DEVELOPMENT APPLICATION ASSESSMENT REPORT

Application Number:	DA2023/0049	
Responsible Officer:	Kye Miles	
Land to be developed (Address):	Lot 25 DP 23008, 92 Narrabeen Park Parade WARRIEWOOD NSW 2102	
Proposed Development:	Alterations and additions to a dwelling house including a swimming pool	
Zoning:	C4 Environmental Living	
Development Permissible:	Yes	
Existing Use Rights:	No	
Consent Authority:	Northern Beaches Council	
Land and Environment Court Action:	No	
Owner:	Angela Louise Simmons	
Applicant:	Minto Planning Services Pty Ltd	
Application Lodged:	30/01/2023	
Integrated Development:	No	
Designated Development:	No	
State Reporting Category:	Residential - Alterations and additions	
Notified:	02/02/2023 to 16/02/2023

Figure 1. Envelope breach on the western elevation shown in red.

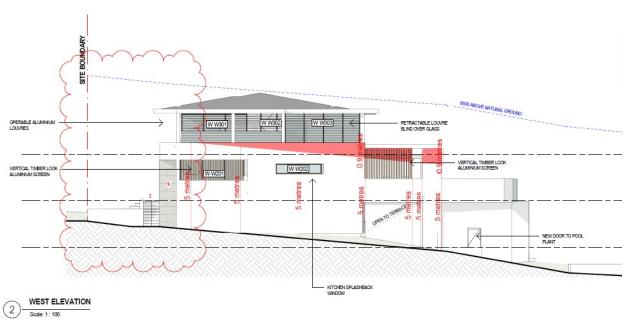
The proposal has non-compliances to the building envelope on both side elevations. The western elevation has two encroachments up to a maximum height of 0.9 metres. The eastern elevation has one encroachment up to 0.2 metres.

The extent of the building envelope non-compliances are shown in the figures below (highlighted in red):
